**MINUTES OF THE REGULAR MEETING OF THE  
PLAN COMMISSION, VILLAGE OF TINLEY PARK,  
COOK AND WILL COUNTIES, ILLINOIS**

**January 6, 2022**

**ITEM #1 PUBLIC HEARING – RESIDENCES AT BROOKSIDE GLEN/MAGNUSON APARTMENTS, SPECIAL USE FOR A PUD SUBSTANTIAL DEVIATION**

**ITEM #2 WORKSHOP/PUBLIC HEARING – PETE’S FRESH MARKET WAREHOUSE OFFICE EXPANSION - SPECIAL USE FOR PUD SUBSTANTIAL DEVIATION, SITE PLAN/ARCHITECTURAL APPROVAL**

Front/East Facade: Currently Proposed (top), Previously Approved (bottom) – Not to scale

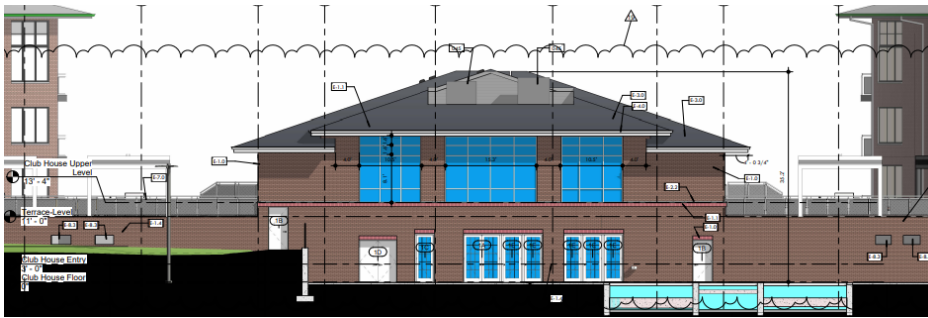
The Petitioner has provided some changes and specifications to the residential entries. The previously approved residential entries showed vertical brick accents and glazing that flanked both the front and rear entry points. The two entry points on the front (east) façade will now have canopies with a continuous cut stone sill and prefinished aluminum gravel stops above supported by piers. The color and line elevations identify them as brick piers punctuated with a 6" high stone accent strip, but the floor plan calls them out as "steel tube columns primed and painted (architectural exposed column)" surrounded by a "stone pier with four way stone cap". However, on the rear (west) elevation, the one canopied large entry point no longer has flanking brick accent. The structural columns are now proposed to be covered on all sides with thin stone, thus it loses the visual differentiation of material as shown in the previous approval. The Petitioner has now specified the glazing for all the residential entry points will be a storefront system with black prefinished aluminum.

**~~Open Item #4: Discuss and clarify the canopy pier materials on the residential front and rear entry points. Consider conditioning they be coordinated and covered on all sides with brick.~~**

### Previously Approved East Warehouse Addition (Looking West):

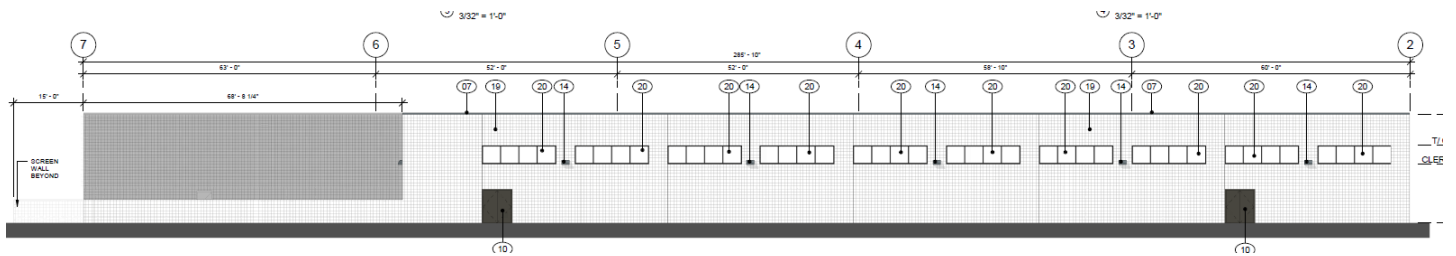
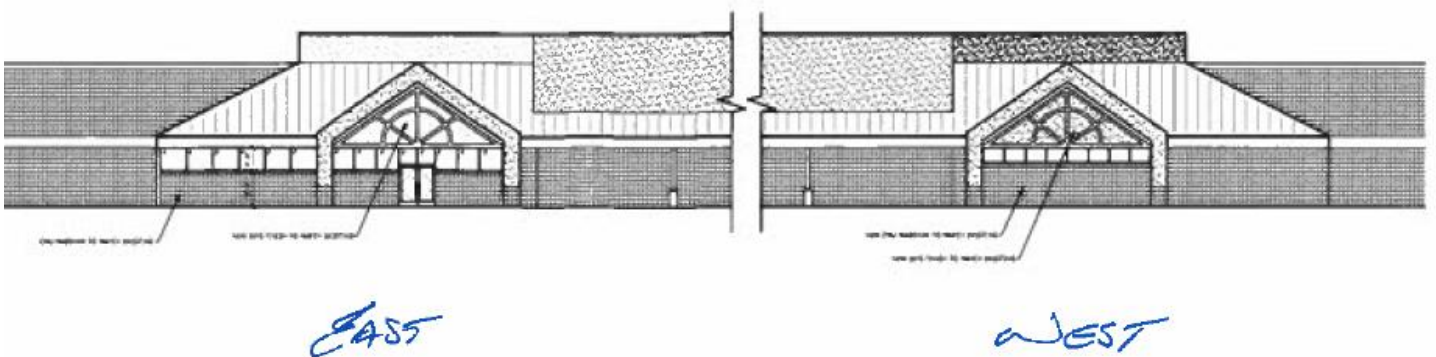
COMMISSIONER TRUXAL noted the drawing submittal is very small and hard to enlarge to view. The whole front section appears to be office space and that females would have to go to the back where the truck drivers are, which would not be optimal. He also questioned if there would be enough facilities for the number of people present.

COMMISSIONER GATTO commented she recalled that as K-Mart it had restrooms up front to the right. Her husband was the GM for that. She commented they were previously all the way to the right. It looks like it is not on this plan now. Previously there was a Little Caesar's, a deli, and restrooms to the right in the corner.

Dan Ritter responded that the internal buildout plans are currently under review by the building official and would need to meet state and local codes. However, the internal operations and locations of bathrooms are not typically under the purview of a site plan review.

### Increased/New Exceptions

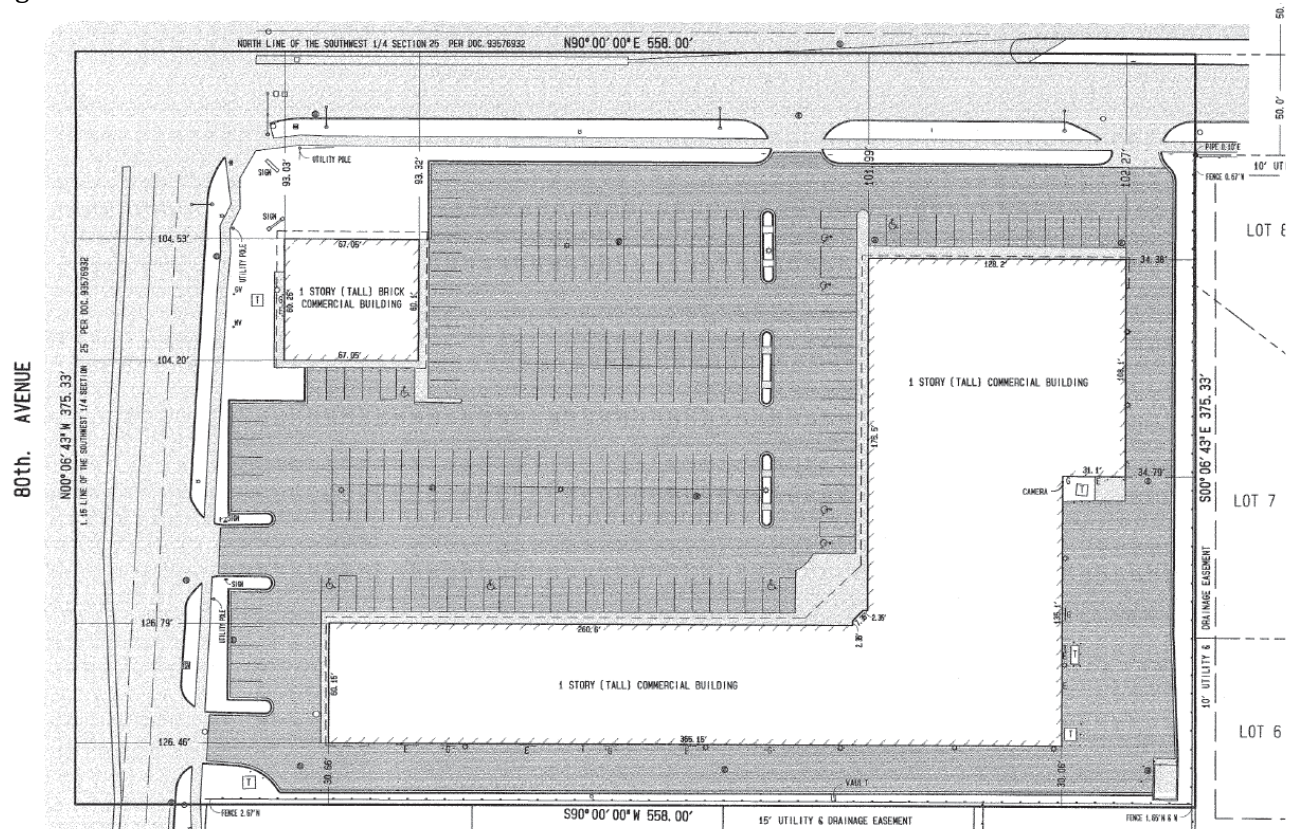
***Open Item #2: Review the requested Exceptions from the Zoning Ordinance as part of the PUD Approval.***

Proposed - Overall

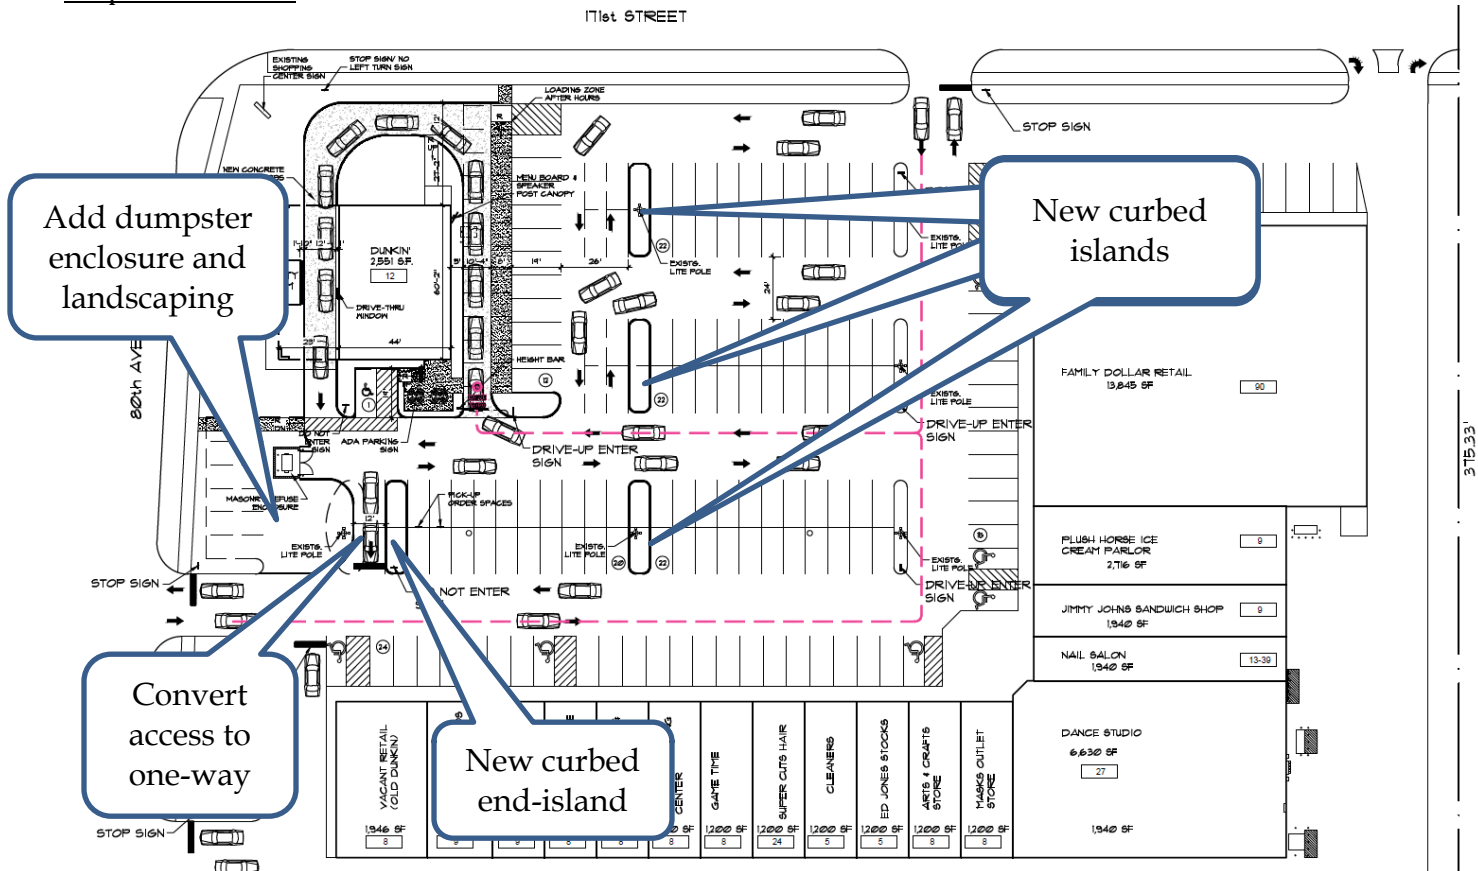
COMMISSIONER SHAW likes this design conceptually. It is unique and will add value. On the southwest corner, it wasn't clear that parking spaces were being removed. That looks good. Having trees along with the portion of the building both help screen the drive-thru itself. He asked if the trees will be planted at maturity.

COMMISSIONER MANI echoed Commissioner Shaw's comment on the chokepoint. He asked that if they could match the new median being created to what's there, and make it skinnier, so that it could be double-way. Possibly the trash enclosure could be shifted to create that opening. Otherwise, as one-way if you take 80<sup>th</sup> Avenue then you have to go all the way around and come back. People might drive between parked cars, creating a hazard. Making a larger opening would allow for people to go both ways.

***Open Item #3: Review the proposed site plan changes and overall site circulation with regards to the drive-thru and the existing businesses within the shopping center.***

Dan Ritter noted most of them are existing and if any die, they will need to replace them. We usually enforce a more mature tree to be planted in that case. For the new trees here, they could put in mature ones, but they are usually 2 1/2" diameter.
